Highway Maintenance Manual

Chapter 9 Right-of-Way Use & Permits

Section 15 Utility Accommodation

Subject 35 Survey Monument Protection

Figure 56. Slope measurement example.

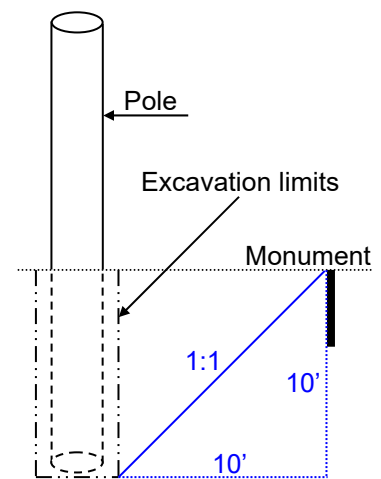
- E Minimum horizontal clearance for a 1:1 slope should be based the vertical distance from the top of a monument to the bottom of the actual excavation or trench. Figure 5-6 shows an example for a 10-foot-deep excavation. Minimum facility or excavation clearance shall be measured horizontally between the nearest edge of a monument and the nearest edge of a utility trench, excavation, pole, pedestal, etc. Where the side of the trench or excavation is not vertical, the part of the trench or excavation side nearest the monument shall be used to measure the clearance distance. Minimum equipment clearance shall be measured horizontally between the nearest edge of a monument and the nearest edge of the equipment tracks, wheels, outrigger stabilization foot pads, frame, bucket, etc. used for making the trench, hole, or excavation or for setting a pole, vault, cabinet, building, etc.
